Planning & Zoning Commission Regular Meeting AGENDA

Monday, January 13, 2020
Ketchum City Hall
480 East Avenue North, Ketchum, ID 83340

STAFF REPORT
KETCHUM PLANNING AND ZONING COMMISSION
REGULAR MEETING OF JANUARY 13, 2019

C1.0

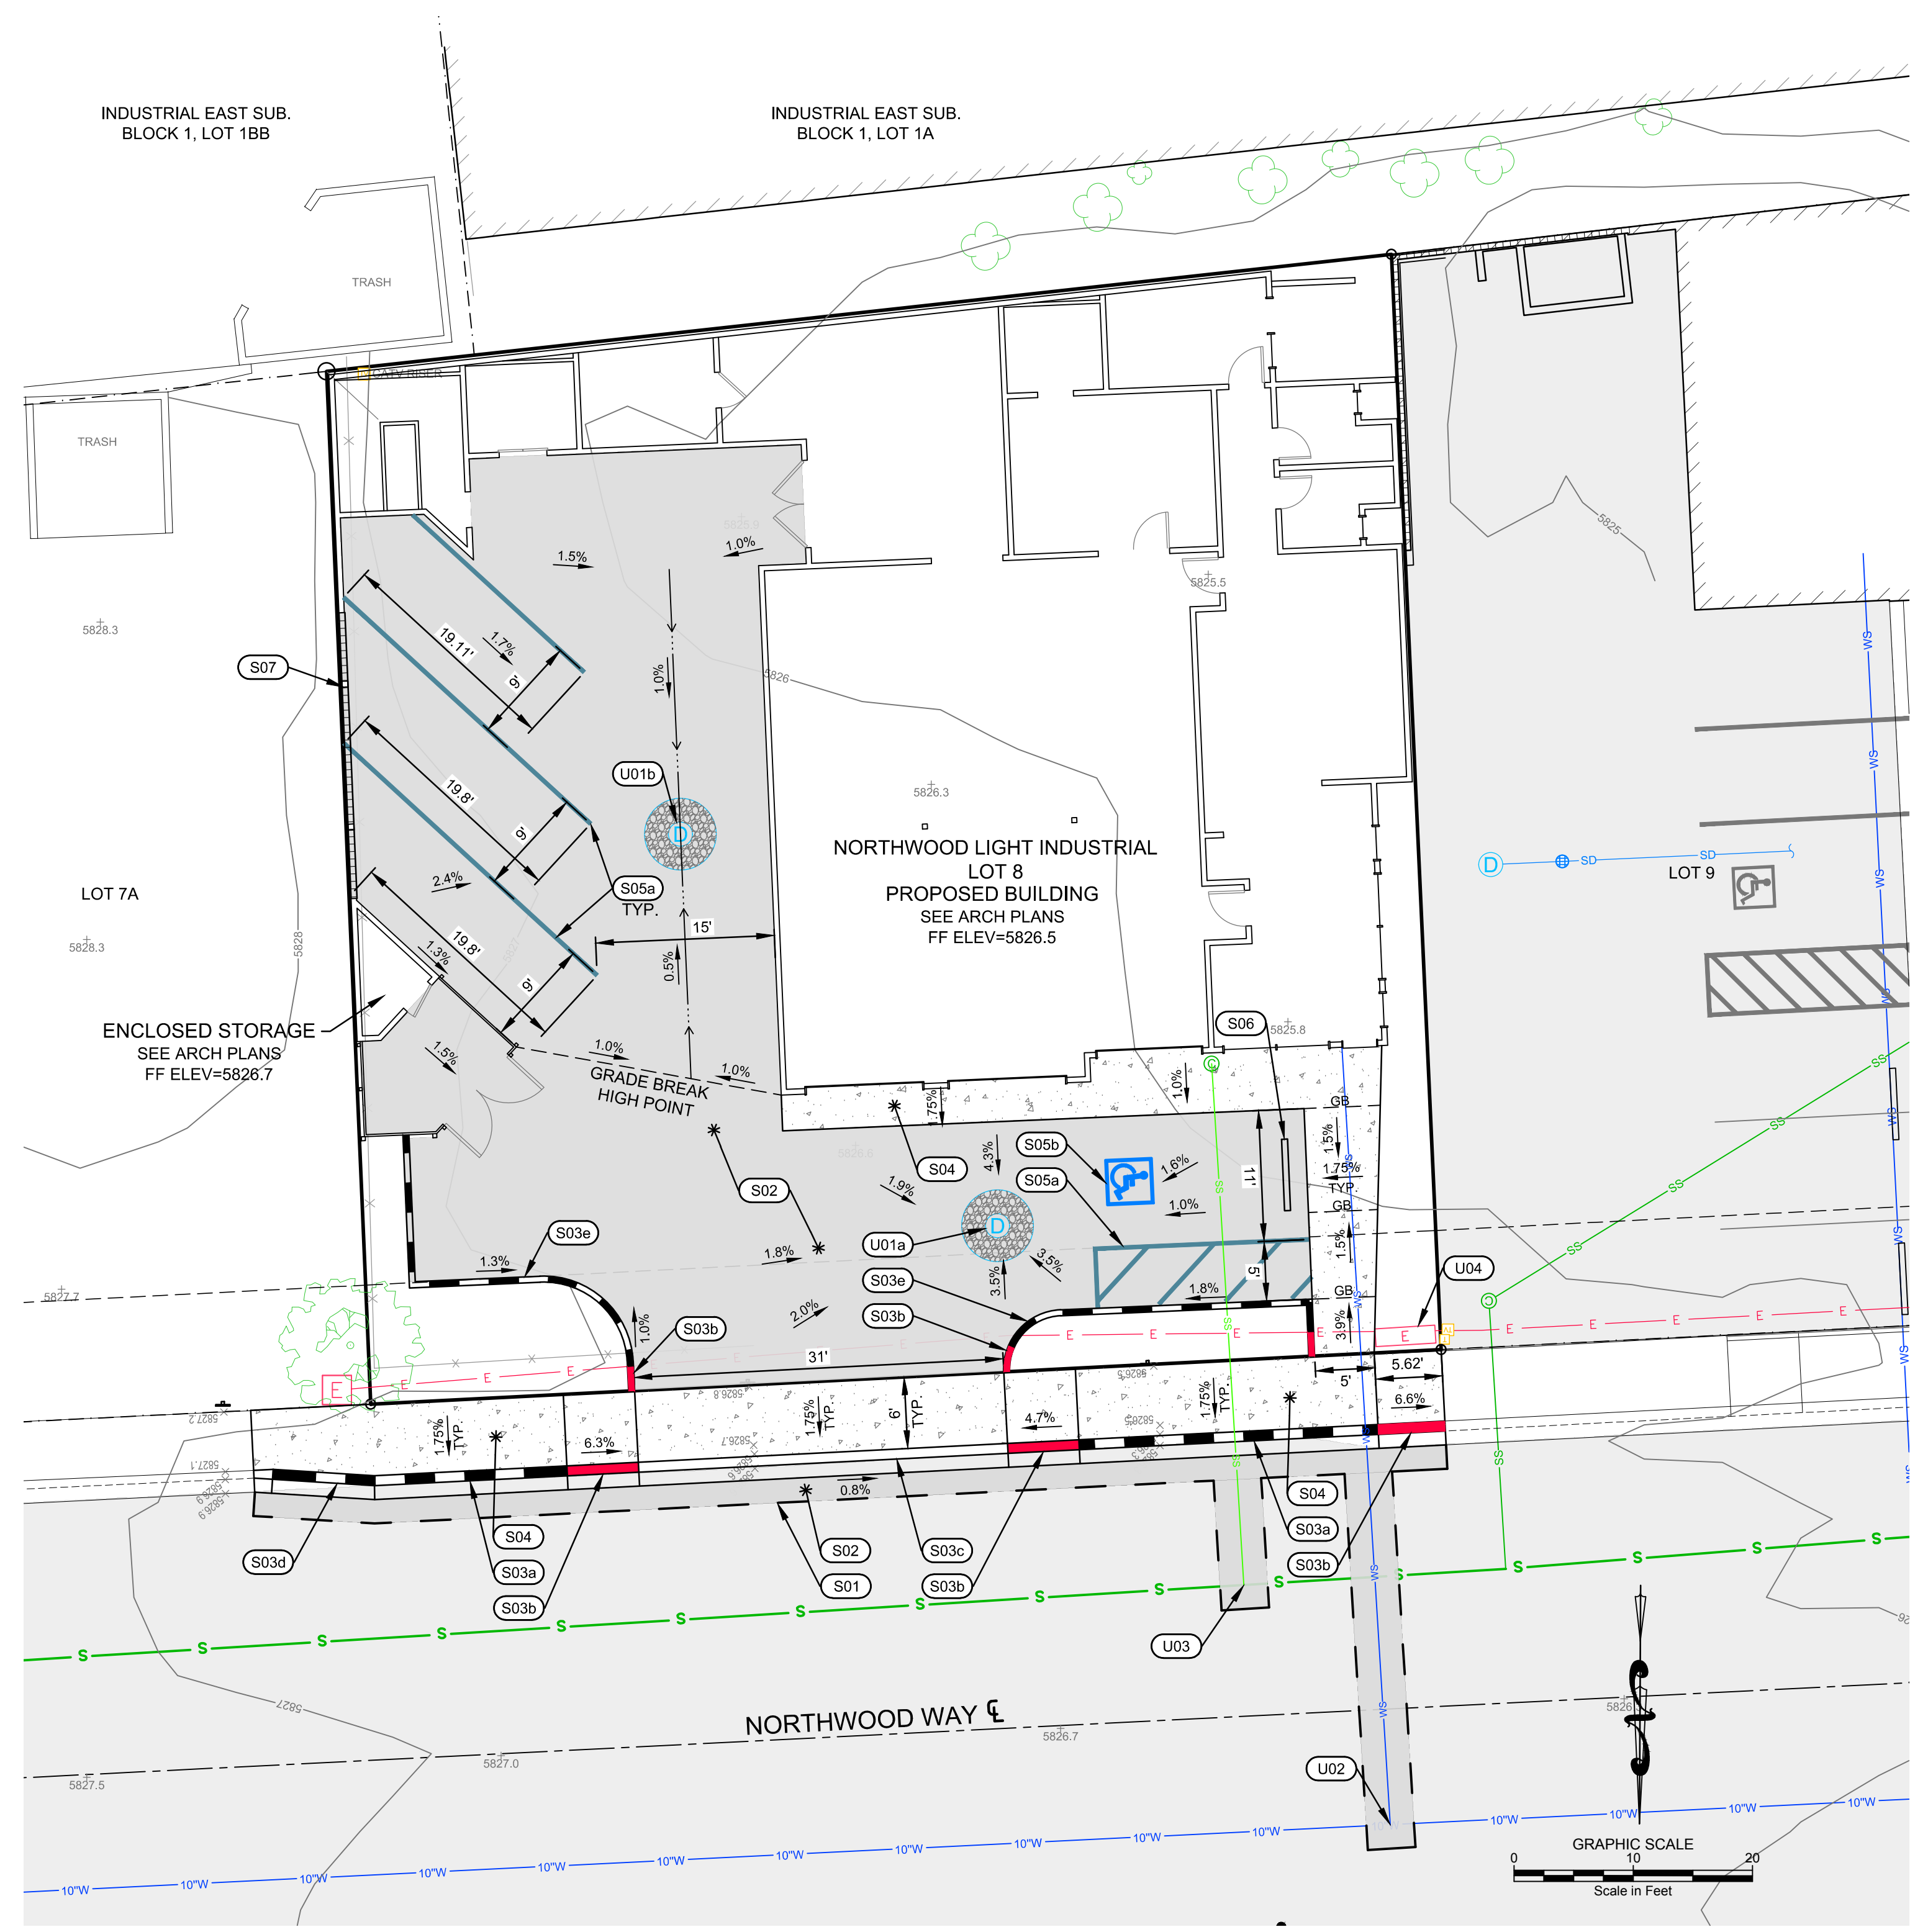
Staff Comments	<i>The applicant as proposed an on-site concrete entry walkway, which will connect to the new concrete sidewalk along Northwood Way (Sheet L1.0). As indicated on Sheet C1.0, the proposed concrete sidewalk will connect to the existing sidewalk along Northwood Way. No new easements or pathways are expected in this vicinity of the Light Industrial zone. Equestrian access is not appropriate in this location.</i>
<input type="checkbox"/>	<input type="checkbox"/>	<input checked="" type="checkbox"/>	17.96.060.G2	Awnings extending over public sidewalks shall extend five (5') feet or more across the public sidewalk but shall not extend within two (2') feet of parking or travel lanes within the right of way.
			Staff Comments	<i>N/A as no awnings are proposed to extend across the public sidewalk.</i>
<input checked="" type="checkbox"/>	<input type="checkbox"/>	<input type="checkbox"/>	17.96.060.G3	Traffic shall flow safely within the project and onto adjacent streets. Traffic includes vehicle, bicycle, pedestrian and equestrian use. Consideration shall be given to adequate sight distances and proper signage.

Figure 2. Area of proposed geogrid installation

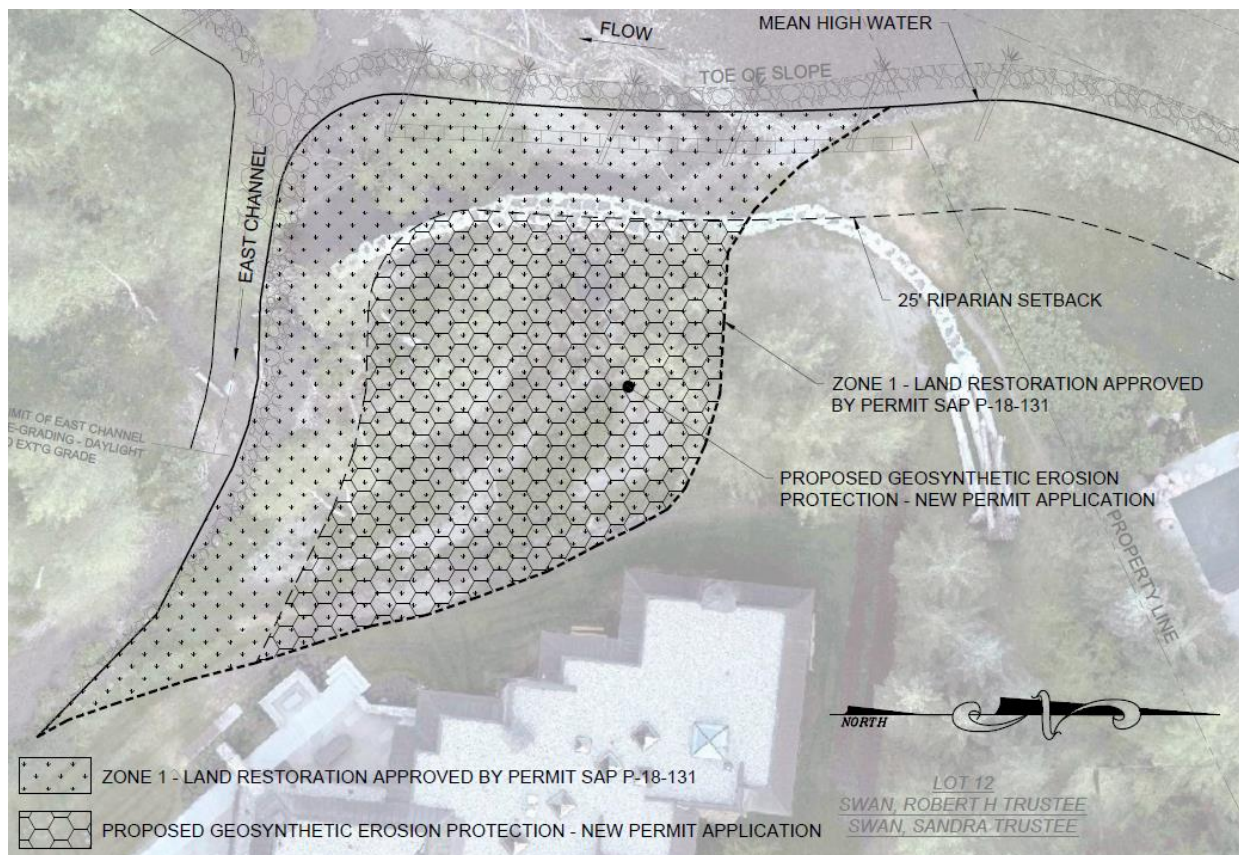
The request before the Commission is for installation of the geogrid, as specified in the Brockway Engineering memo dated November 14, 2019 and the plan drawings dated November 14, 2019 (attachment B) in a land area approximately 7,023 square feet in size.

C. Concerns with the geogrid product

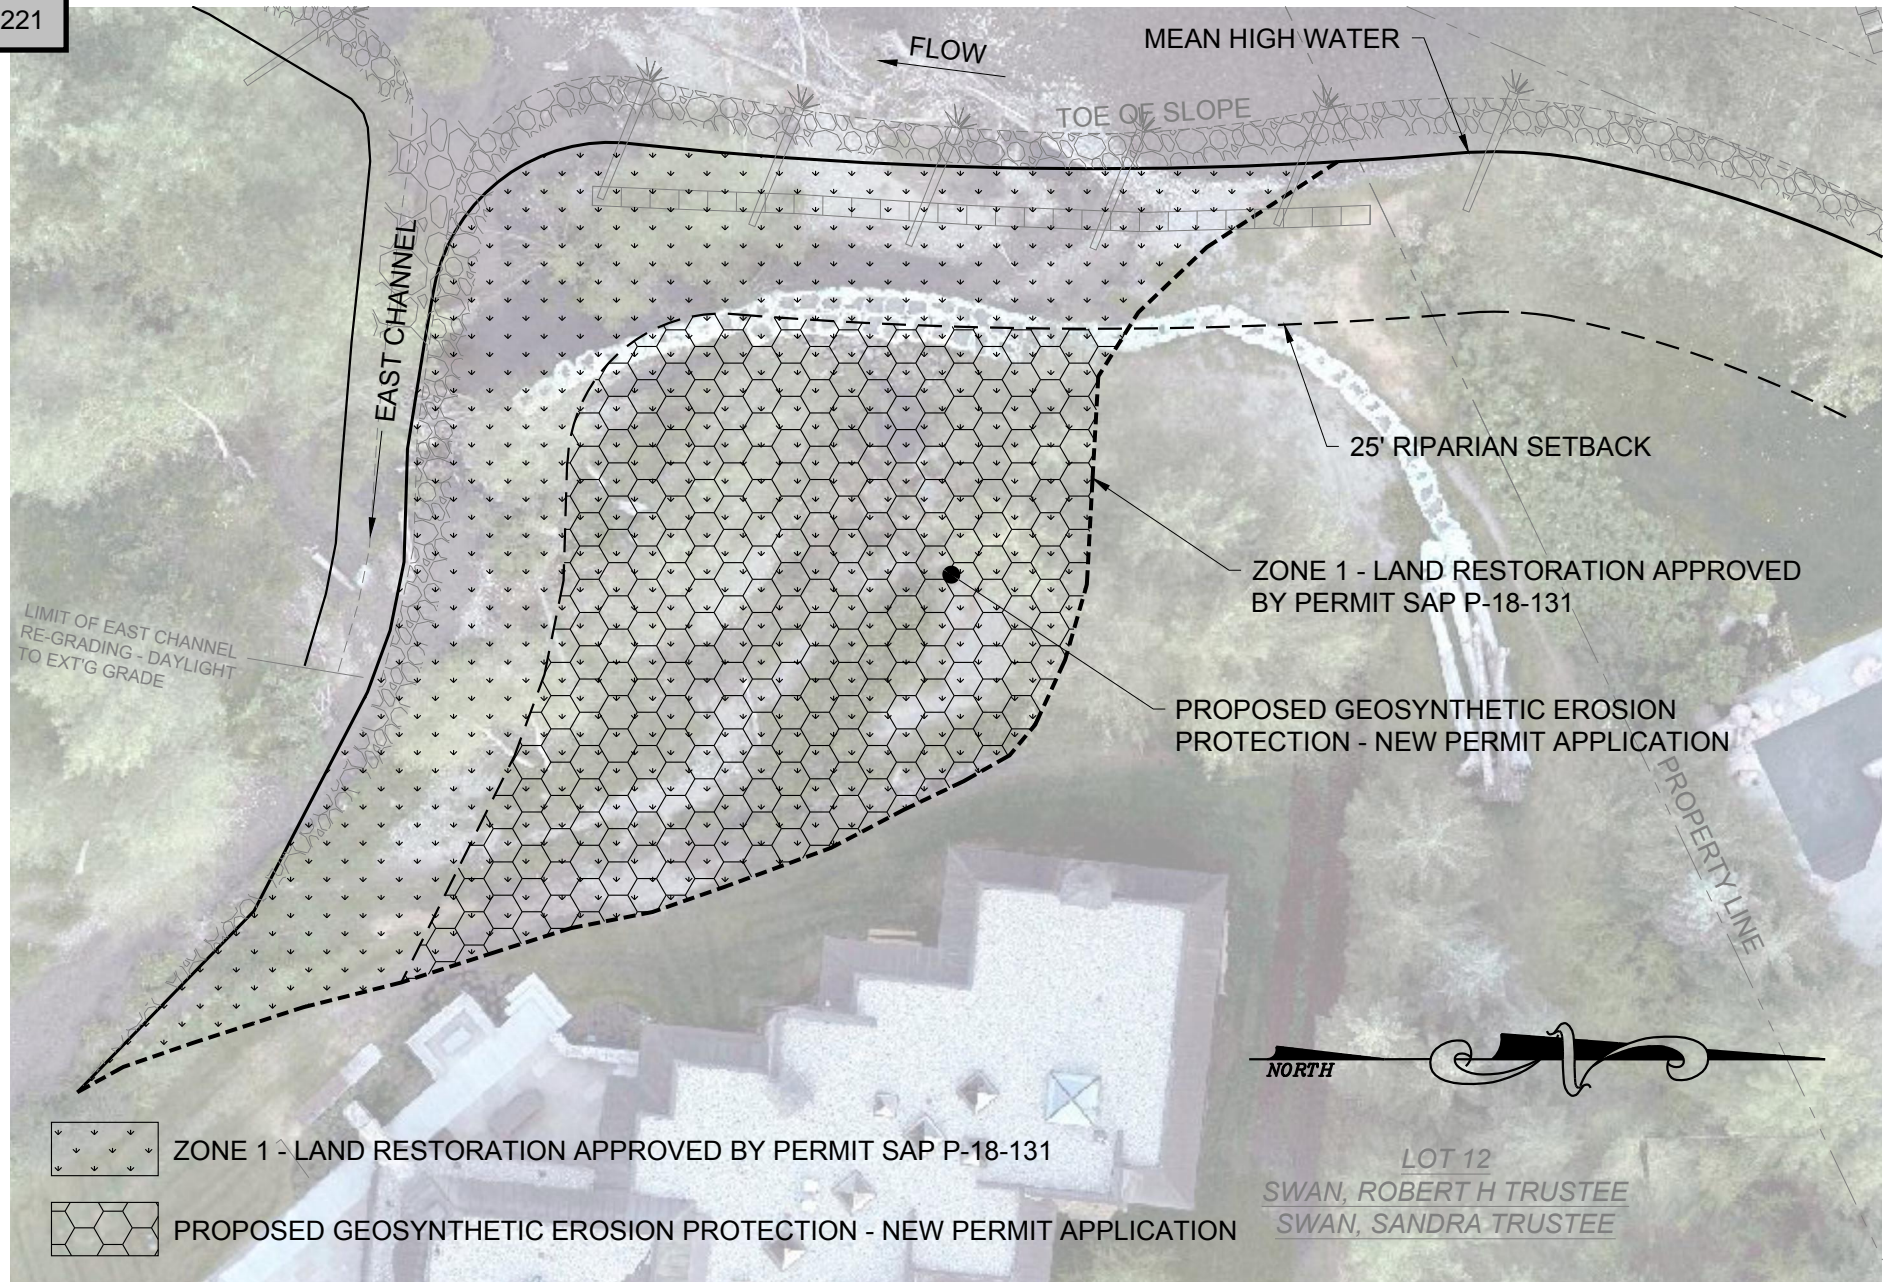
City staff has expressed some concerns regarding the efficacy of the geogrid, each of which is addressed as follows.

The geogrid may be an impediment to movement of water and/or biological organisms through the soil. The material comprising the honeycomb is perforated and does not prevent the movement of water, roots, or organisms.
